TO ALL OUR CUSTOMERS

1. NEW PRODUCTS: CUBIK SERIES DERIVATION BOXES

3. NEW ALUBOX SERIES JUNCTION BOX

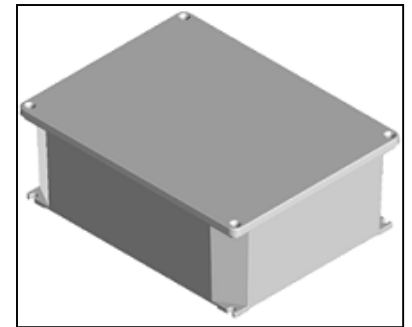
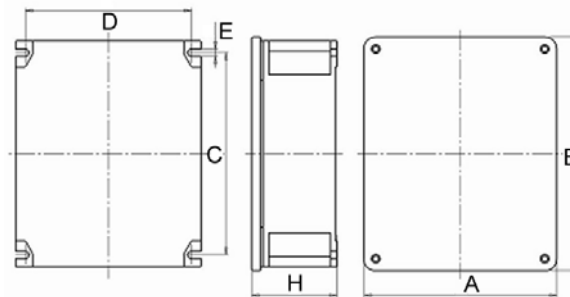
A new aluminum alloy junction box is designed. The new box will have the following dimensions: 410x315x150mm. Its technical features are in line with the ALUBOX series. The degree of protection is also standardized to the rest of the Series: IP66. The corresponding mounting plate (in zinc-plated steel) is created with the box as well.

Please find here below the dimensions of our new box.

Item Code	A (mm)	B (mm)	H (mm)	C (mm)	D (mm)	E (mm)
653.07	315	410	151	283	367	9
